CITY VIEW AVE. - LITTLE DIAMOND  
105-N-3-4-6-7-15  
ISL.

## SUBSURFACE SEWAGE DISPOSAL PERMIT FOR THE TOWN/CITY OF Portland

MAINE DEPARTMENT OF HEALTH AND WELFARE  
APPLICATION FOR PRIVATE SEWAGE DISPOSAL PERMIT

We are in receipt of your revised leaching chamber system dated May 15, 1976.

RAND  
LEACHING  
CHAMBER  
SYSTEM

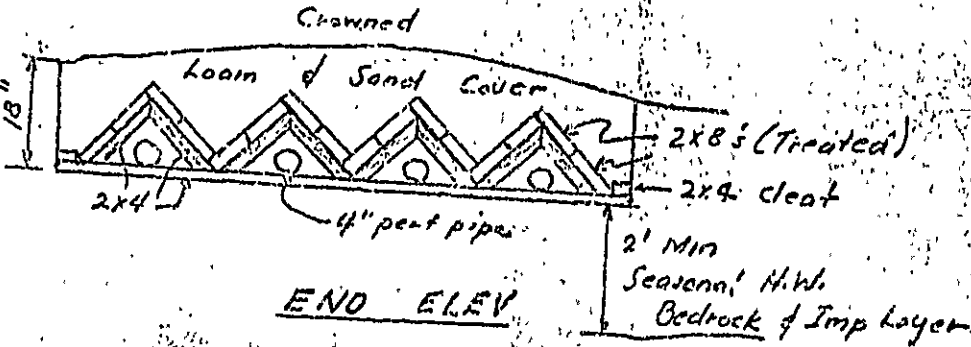
In principal, we feel that these chamber systems you propose may be a simple and economical answer for the Maine islands where there is difficulty in obtaining stone and sand and constructing conventional disposal systems.

We have several concerns about the sizing of your systems, particularly in the Medium and Large Systems where we question whether the size would be adequate: if you are installing them directly over silts where percolation rates are in excess of 60 minutes per inch. The 24 x 24 plank chamber systems, assuming the mat is the limiting factor for ultimate failure, appear to be adequate to handle approximately 150 gallons per day.

Persons having these systems installed should be aware of the fact that it may be necessary from time to time to remove the planks and physically remove the mat or at some point in time add on to the systems should a problem occur.

The Department is prepared to permit the installation of these plank chamber systems on the islands in Casco Bay on a trial basis, with the understanding that should they appear to be undersized that they will have to be added onto.
